Staff Report

To: Salt Lake City Planning Commission
From: Mayara Lima, Principal Planner
(801) 535-7118 or mayara.lima@slcgov.com
Date: August 14, 2019
Re: PLNPCM2019-00408 – Best Western Glo Design Review

Design Review

PROPERTY ADDRESS: 1865 W North Temple
PARCEL ID: 08-34-353-006
MASTER PLAN: Northwest Master Plan
ZONING DISTRICT: TSA-MUEC-C Transit Station Area District, Mixed Use Employment Center Station, Core

Image 3 – North Temple façade on top and Orange Street façade below.

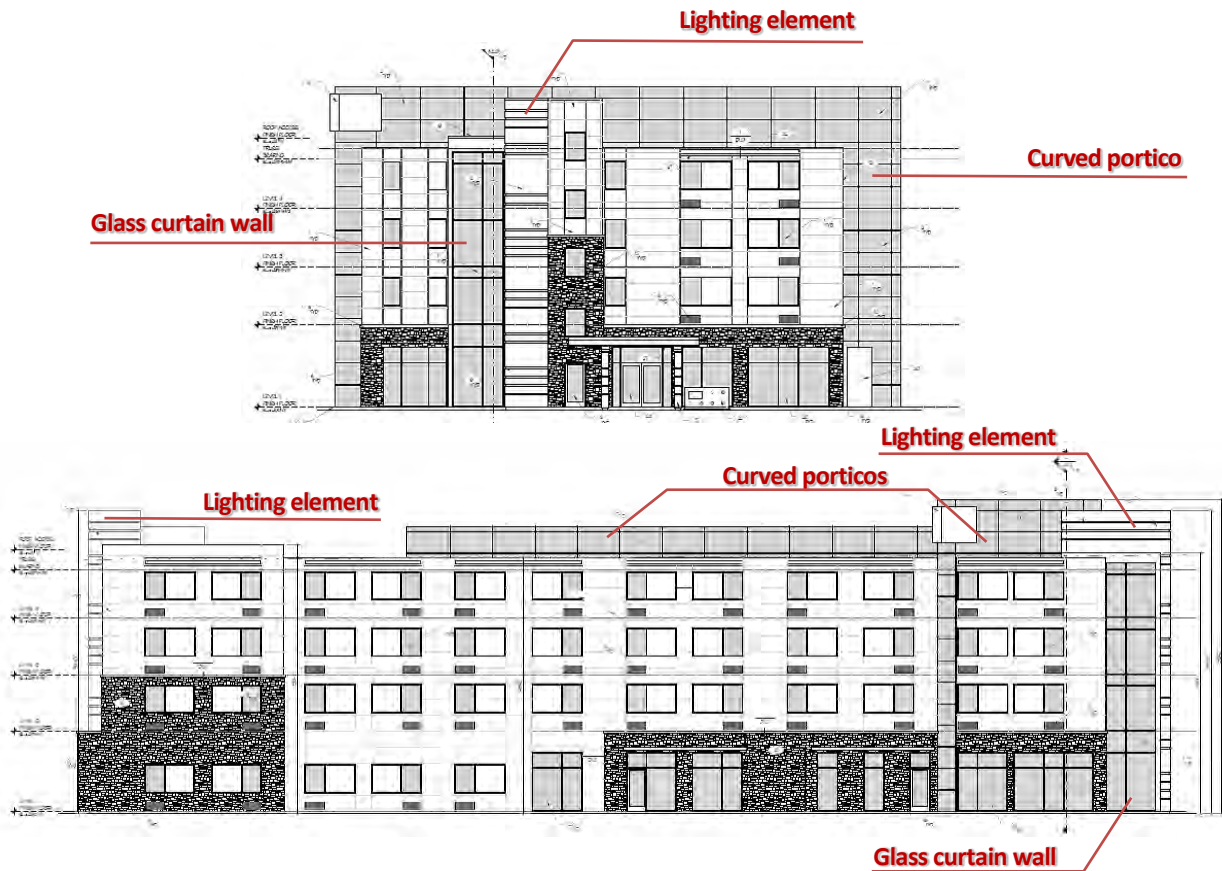
- **Maximum corner side yard setback of 15 feet**
The applicant is proposing that the building be setback approximately 29.5 feet from the property line along Orange Street due to existing electrical transmission lines that run along the west property line. To reduce the distance, roof overhangs, outdoor seating plaza and public plaza are being proposed within the setback area.

- **One building entrance for every 40 feet of a street facing facade**
The applicant is proposing two entrances on the façade along Orange Street, as opposed to the five that are required. This modification is motivated by the location of the guest rooms on the ground floor of the building and general hotel operations. The proposed entrances on the façade along North Temple complies with this standard.

- **Street facing façade no longer than 200 feet**
The façade along Orange Street is approximately 204 feet long. To visually break up the façade, the façade is proposed with changes in material, massing and vertical plane.

The modifications requested largely affect how the building is perceived from Orange Street. Orange Street is an approximately 40-foot-wide road that extends for a little over a quarter mile south of North Temple and then dead ends into Interstate 80. The street does not have continuous curb along the road bed and has inconsistent sidewalks, existent only where development occurred recently. In order to create the environment intended for this transit-oriented district, new development should be promoting engagement with the street in a way to make it more walkable and attractive. This includes physical improvements to the right of way, as well as increasing the street presence through the careful design of the buildings and its surroundings.

In recognizing the potential issues created by the modification of the TSA zoning requirements, the applicant is proposing an enhanced landscaped area, roof overhangs, public and semi-private uses within the increased setback, and changes in building materials. Glazing will be maximized, although it cannot be all transparent, and side doors will connect the building to the street via defined walkways. The use of stone and metal panels will create some interest in the building façade and the proposed outdoor spaces along Orange Street will connect enclosed/private to the open/public.

Image 4 – Proposed landscape plan

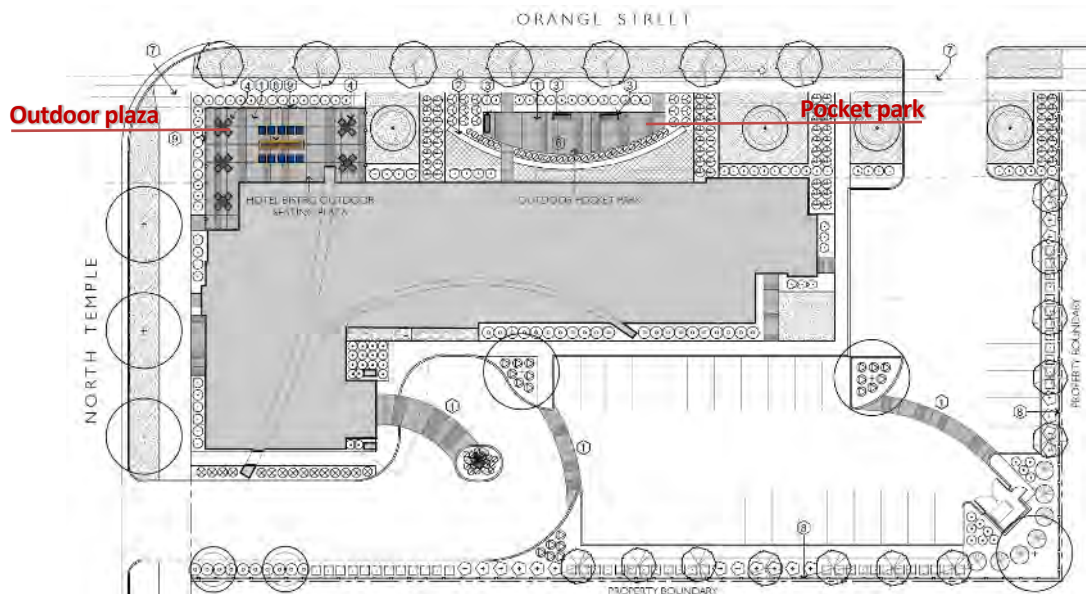
The pocket park will be a small paved area, surrounded by landscape and enfolded by a curved wall that matches the building. The outdoor seating plaza will have a low, wrought iron fencing that will delineate the private space without compromising the visual connection with the sidewalk. These spaces create an opportunity for the public to engage with the building and provide an appropriate transition between the enclosed private hotel space and the open public realm.
